STAFF RECOMMENDATION

115 Scott Avenue

July 21, 2021

Application: New Construction—Addition
District: Eastwood Neighborhood Conservation Zoning Overlay
Council District: 06
Base Zoning: R6
Map and Parcel Number: 08306028200
Applicant: Cheyenne Smith
Project Lead: Melissa Baldock, melissa.baldock@nashville.gov

SITE PLAN AND
FLOOR PLAN

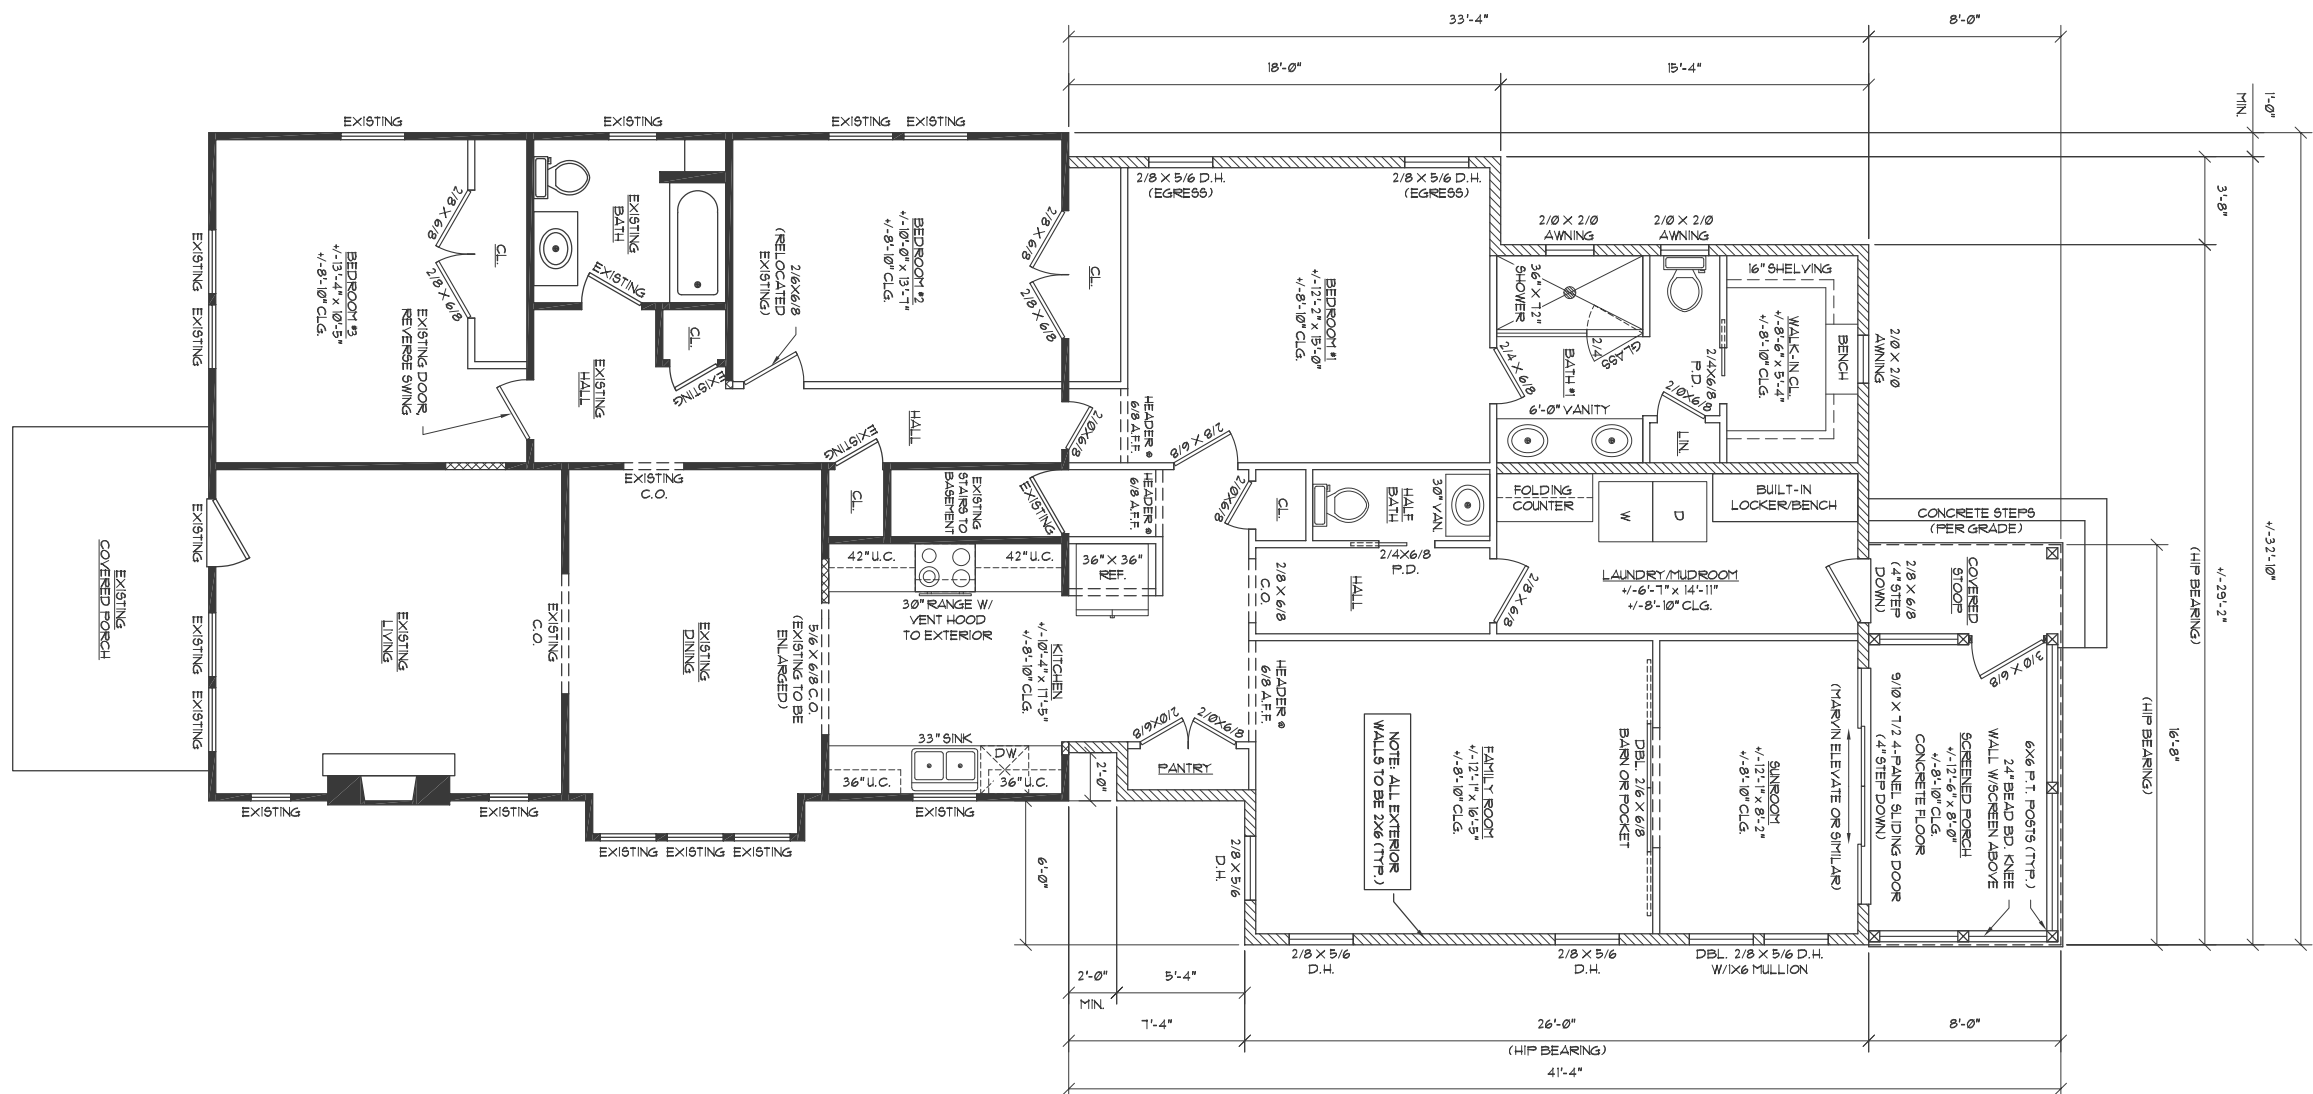
The addition is inset one foot (1') from both back corners of the historic house. On the left side, the addition is inset for its entire depth. On the right side, the addition has a one foot by two foot (1'X2') alcove, after which point the addition steps back out to be six feet (6') wider than the historic house. Staff finds that this wider portion of the addition meets the design guidelines because the house is less than thirty feet (30') wide at just twenty-eight feet (28'). The addition is also no taller than the historic house and is slightly lower in height.

The addition will approximately double the footprint of the historic house, adding approximately one thousand, one hundred and ten square feet (1,110 sq. ft.) to it. By comparison, once the non-historic additions are removed, the footprint of the historic house is approximately one thousand, one hundred and twenty-five square feet (1,125 sq. ft.).

Siting and Setback: The addition is situated at the rear of the house and meets all base zoning setbacks. It is just five feet (5’) from the right side property line, approximately thirteen feet (13’) from the left side property line, and over twenty feet (20’) from the rear property line. The addition is less than twenty feet (20’) from an existing garage at the rear of the house. There will be about eleven feet (11’) between the back of the addition and the existing garage. Staff, however, finds this to be appropriate in this instance because the addition’s footprint is designed so that there is minimal overlap on the site plan between the garage and the new addition.

EXTERIOR
ELEVATIONS

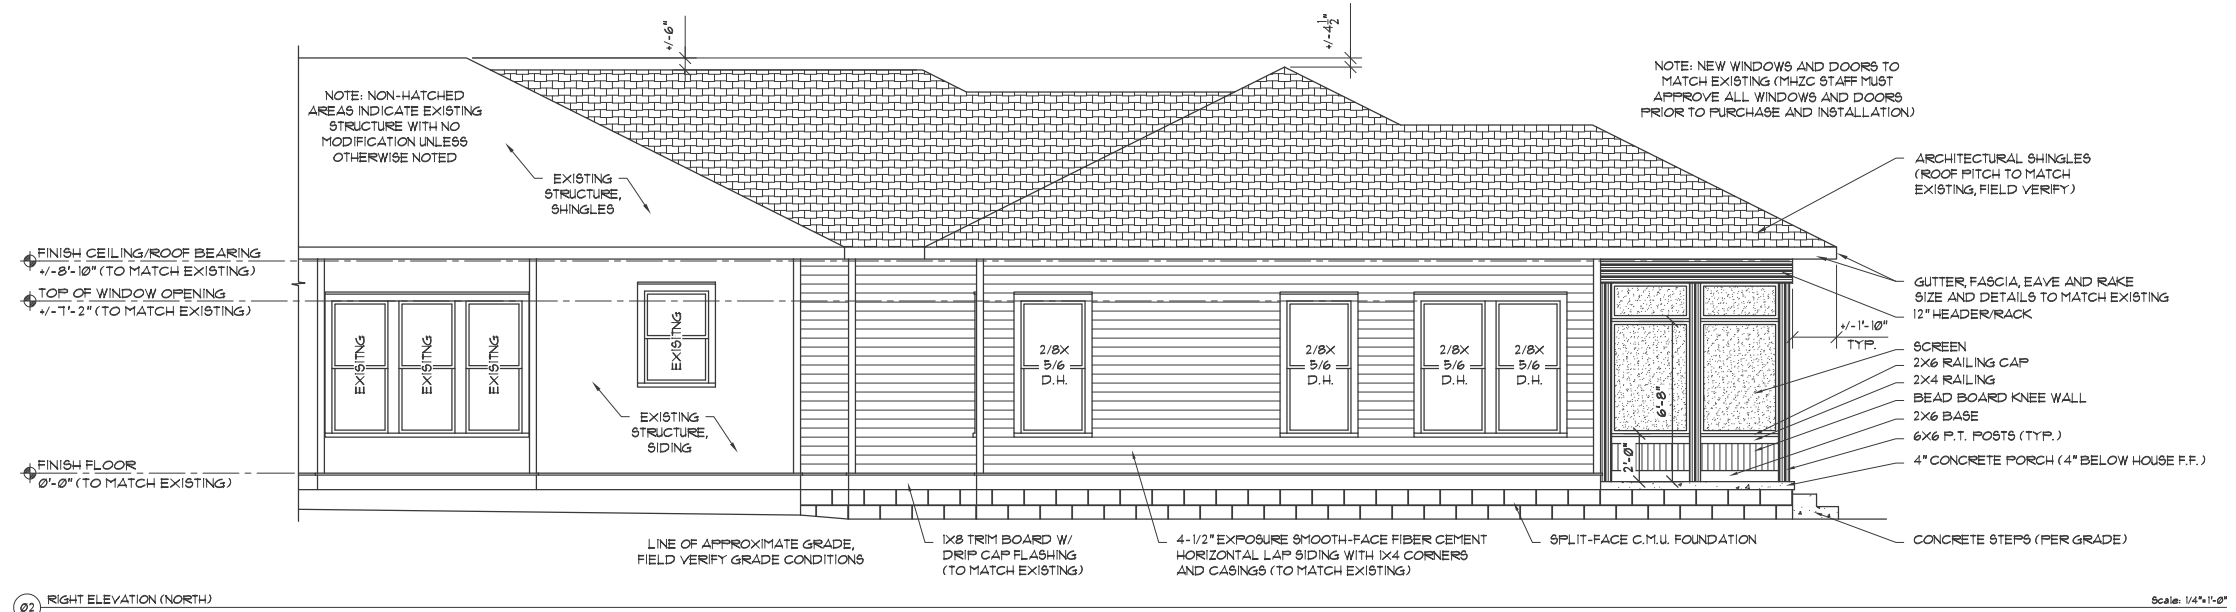
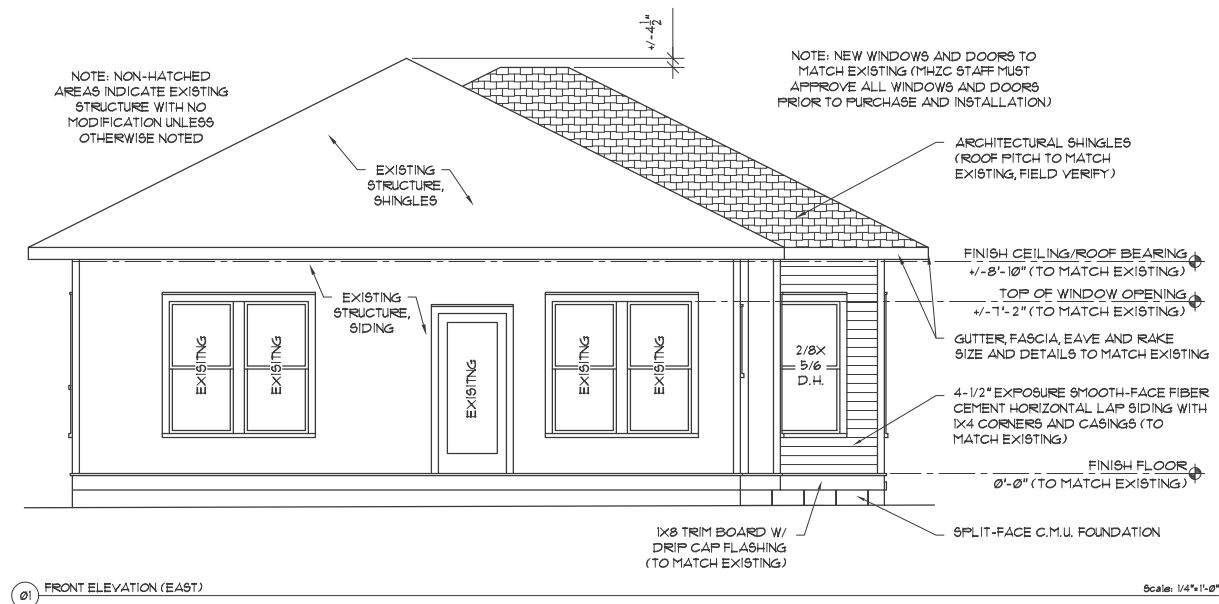
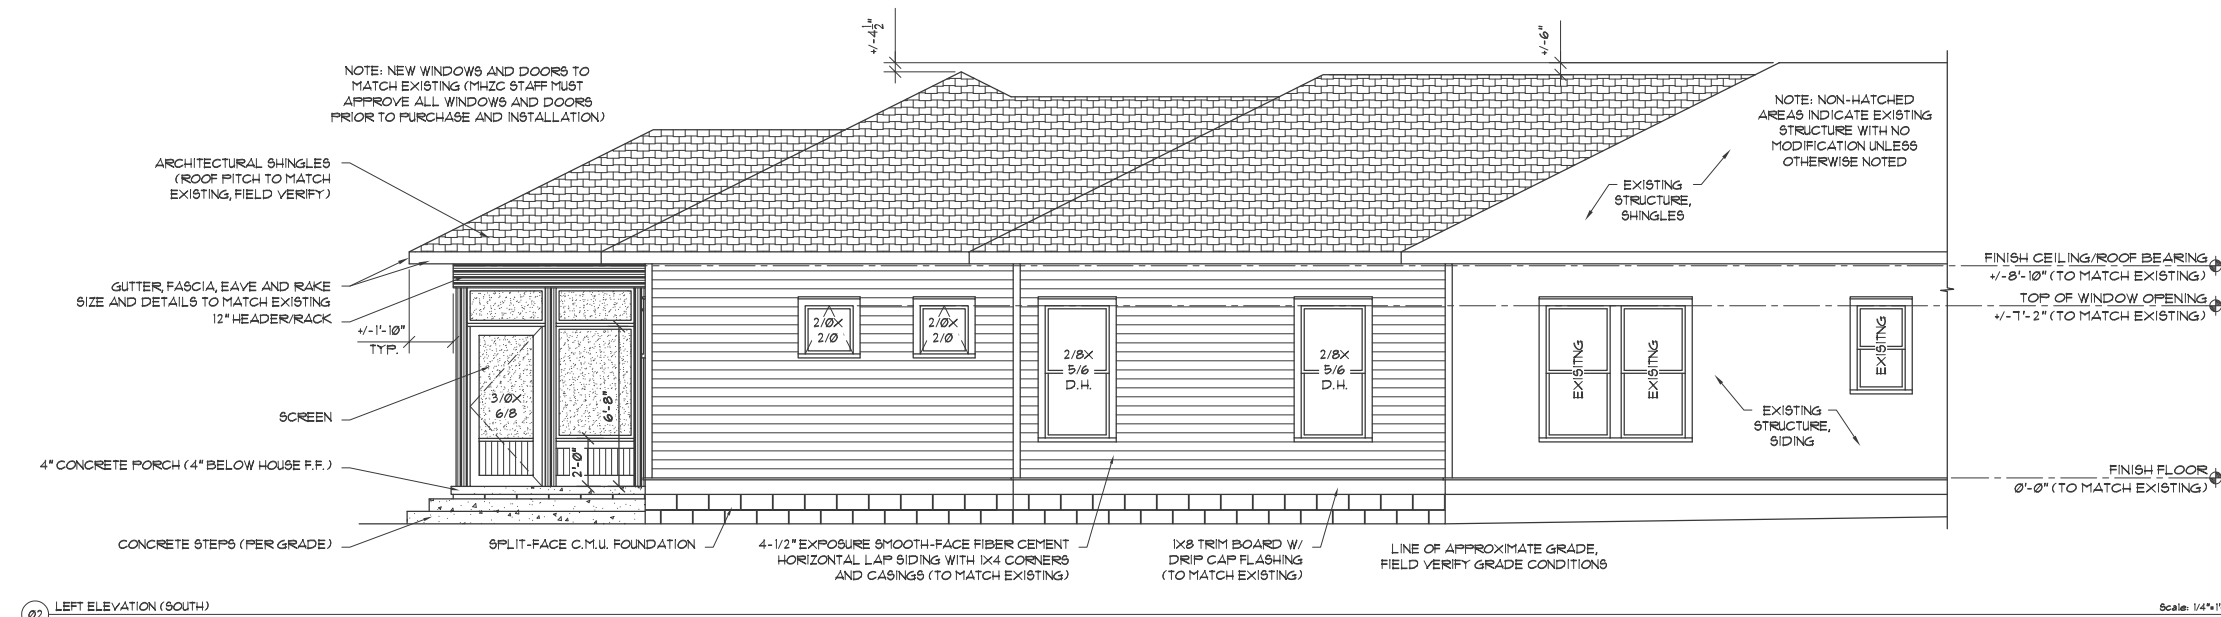
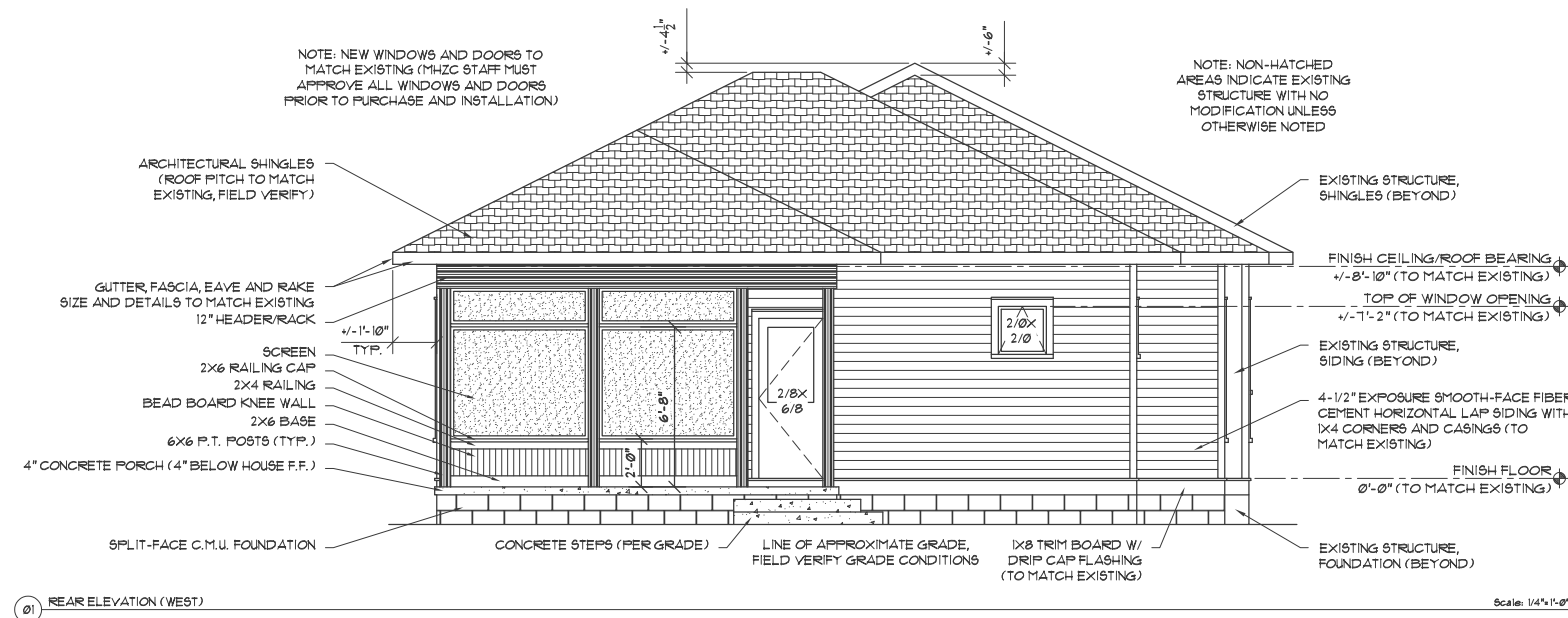
Mass, Scale and Connection: The applicant proposed a one story addition that is approximately four inches lower in height than the historic house, attached to the rear of the house. The addition's eave and foundation heights will match that of the historic house.

Roof form: The addition’s roof form is compatible with that of the historic house. It ties into the historic house approximately four inches lower than the house’s ridge. Its primary forms are 7/12 hipped roofs that approximate the roof slopes and forms of the historic house.

Proportion and Rhythm of Openings: The changes to the windows on the historic house were discussed under "Partial Demolition." The windows on the proposed addition are all generally twice as tall as they are wide, thereby meeting the historic proportions of openings. There are two square windows on the left façade, towards the back, on an inset wall. Staff finds that these will not be highly visible from the street and are therefore appropriate. There are no large expanses of wall space without a window or door opening.
